UNITED STATES PATENT AND TRADEMARK OFFICE

APPLICATION NO.	FILING DATE	FIRST NAMED INVENTOR	ATTORNEY DOCKET NO.	CONFIRMATION NO.
10/817,613	04/02/2004	Andreas Kimmerle	LORWER P28AUS	2469

Office Action Summary	Application No. 10/817,613	Applicant(s) KIMMERLE, ANDREAS	
	Examiner Jimmy T Nguyen	Art Unit 3725

DETAILED ACTION

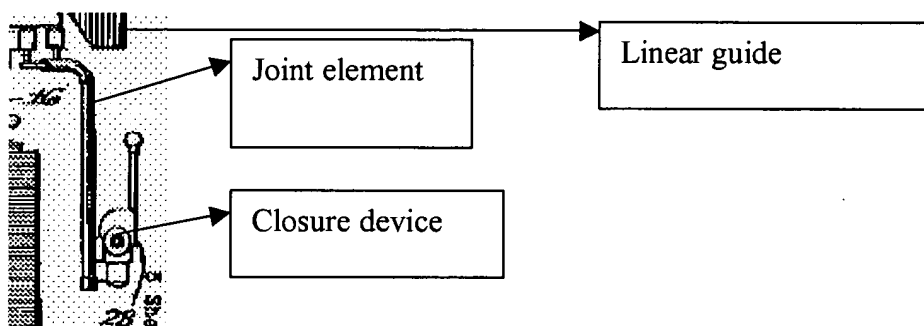
Claims 20, 21, and 22 are rejected under 35 U.S.C. 102(b) as being anticipated by Sterner (US 3,150,585).

Regarding claim 20, Sterner discloses an apparatus for strapping and bundling pallets and articles (1), having a strapping device (fig. 1) from which a strapping band (S) can be passed around the pallets and articles and the apparatus having a closure device (28) for tensioning and closure of the packaging band (col. 3, lines 13-17); wherein the strapping device is provided with

a guide device (7, 8, 9) on which the closure device is arranged (fig. 1), the guide device support “at least some” of the weight of the closure device (fig. 1).

Regarding claim 21, the guide device has a linear guide (7, 9), at one of whose ends (see the right end of element (7) in fig. 1) the closure device (28) is arranged (fig. 1).

Regarding claim 22, the closure device is arranged such that the closure device (28) can move (see col. 3, lines 13-16) on the linear guide by a joint element (see the illustration below).
